**DATE:** December 21, 2016  
**TO:** Jeremy Schaub, Gabriel Ng Architects Inc.  
**FROM:** Joy Navarrete, Planning Department  
**RE:** PPA Case No. 2016-012529PPA for 2214 Cayuga Avenue and  
3143 Alemany Boulevard

## Preliminary Project Assessment

*Date:* December 21, 2016  
*Case No.:* **2016-012529PPA**  
*Project Address:* 2214 Cayuga Avenue & 3143 Alemany Boulevard  
*Block/Lot:* 7146/001, 034  
*Zoning:* Neighborhood Commercial, Cluster (NC-1) Zoning District  
40-X Height and Bulk District  
*Area Plan:* N/A  
*Project Sponsor:* Jeremy Schaub, Gabriel Ng Architects Inc.  
(415) 682-8060  
*Staff Contact:* Christopher Espiritu – (415) 575-9022  
Christopher.Espiritu@sfgov.org

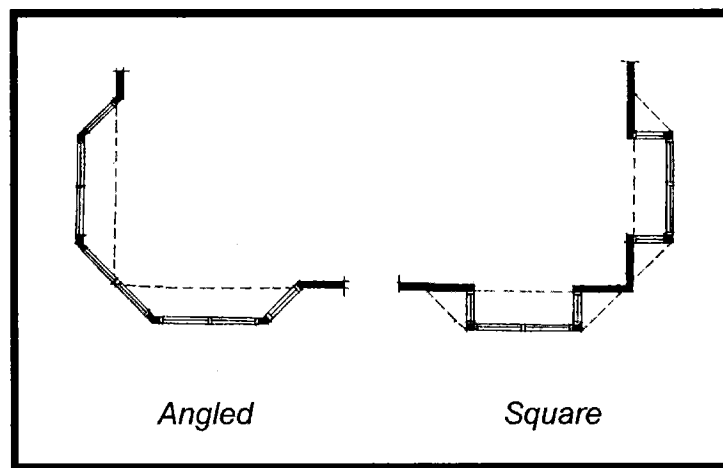
2. **Permitted Obstructions.** Section 136(c) permits bay window projections into the required open area provided such projections shall be limited to three feet, provided that projection over streets and alleys shall be further limited to two feet where the sidewalk width is nine feet or less, and the projection shall in no case be closer than eight feet to the centerline of any alley. Additionally, each bay window or balcony over a street or alley, setback or rear yard shall also be horizontally separated from interior lot lines (except where the wall of a building on the adjoining lot is flush to the interior lot line immediately adjacent to the projecting portions of such bay window or balcony) by not less than one foot at the line establishing the required open area, with such separation increased in proportion to the distance from such line by means of a 135-degree angle drawn outward from such one-foot dimension, reaching a minimum of four feet along a line parallel to and at a distance of three feet from the line establishing the required open area

The proposed bay windows do not all appear to comply with the interior lot separation. Also, the proposed corner bay windows exceed the maximum allowed dimensions. See diagram below for what the size limits for corner bay windows are:
